RE: Final Decision and Corrective
Measures Implementation Order
EKCO Housewares, Inc.
OHD 045 205 424

**FINAL DECISION AND
RESPONSE TO COMMENTS**

ATTACHMENT II
U.S. EPA RESPONSE TO COMMENTS

FIGURE 1 PREVIOUS AND PROPOSED SOIL BORING LOCATIONS

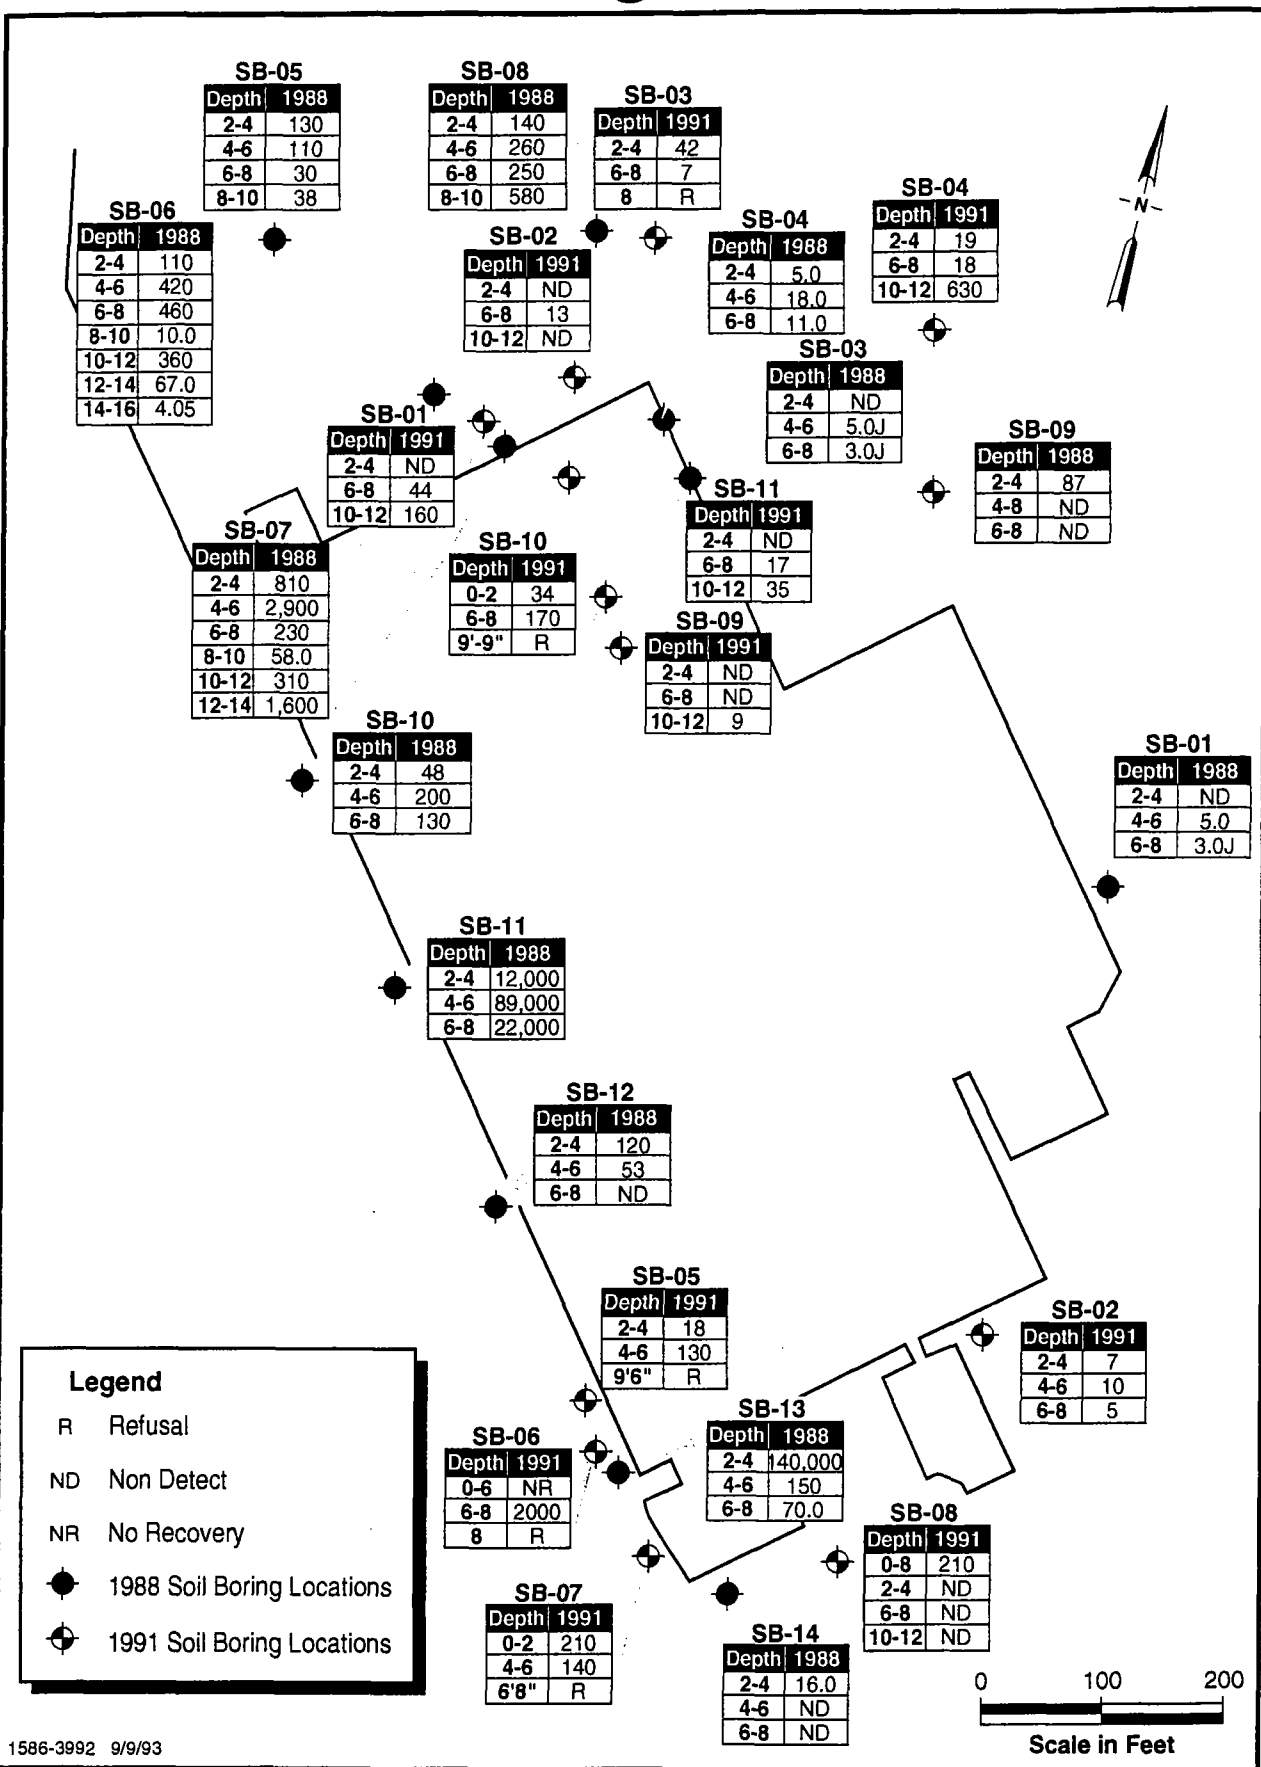
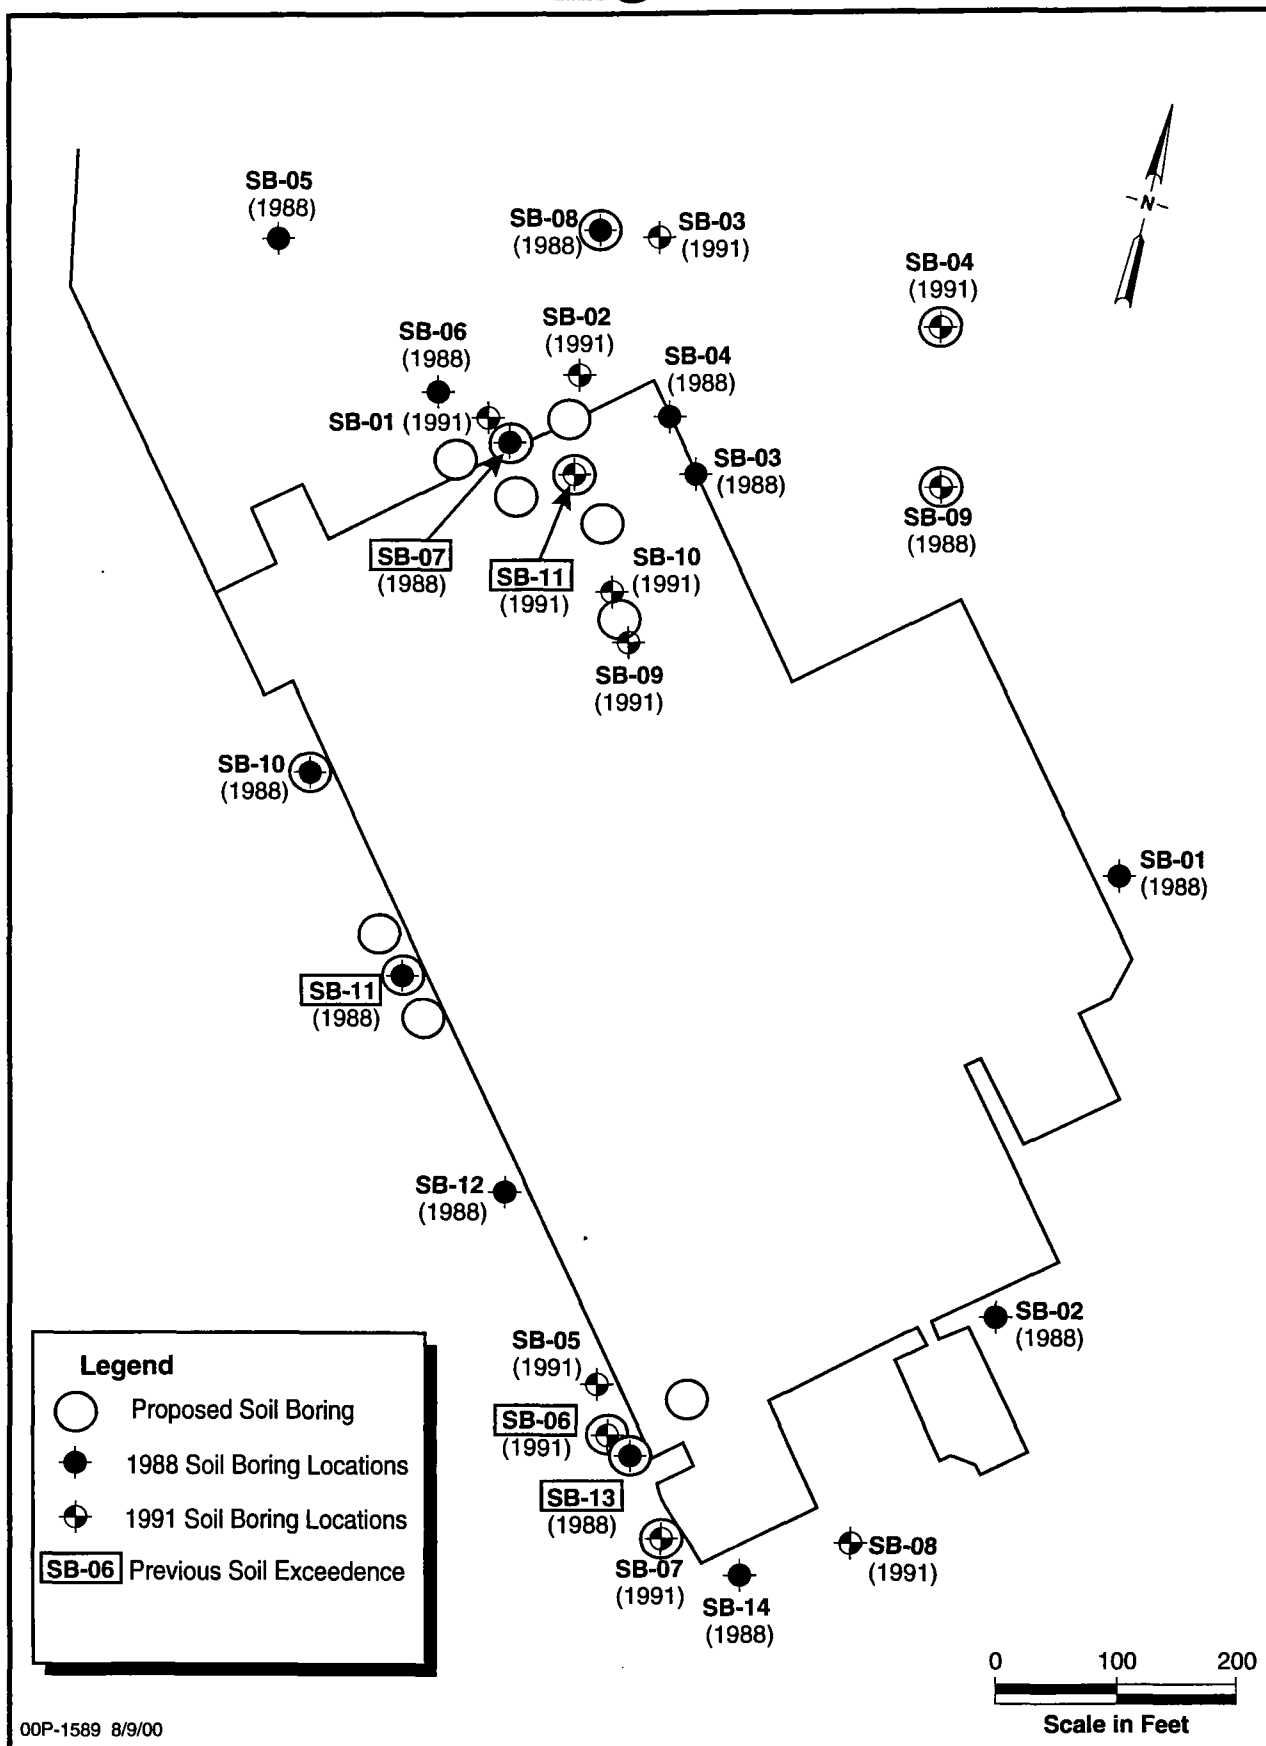
1) Based on soils data presented in the November 1993 Final CMS Report, significant concentration of VOCs were found in four areas as depicted in Figure 2-6 of the Final CMS Report. A review of soils data presented in Figures 2-1 through 2-5 of the Final CMS report generally shows significant detectable concentrations of VOCs at the following locations:

In order to ensure that all potential areas of soil contamination are addressed and risks properly assessed during the proposed Geoprobe soil sampling program, U.S. EPA requires that areas identified above be accurately characterized using EPA SW-846, Update III methods. Accordingly, modify Figure 1 showing the 12 proposed soil boring locations to include six additional sample locations at SB-07 (1991), at SB-10 (1988), between SB-09 (1991) and SB-10 (1991), at SB-08 (1988), at SB-04 (1991) and at SB-09 (1988).

Response to Comment No. 1: The six additional Geoprobe soil boring locations requested by the EPA will be included in the proposed effort. A revised Figure 1, which shows the 6 new soil boring locations, is included as **Attachment 3**.
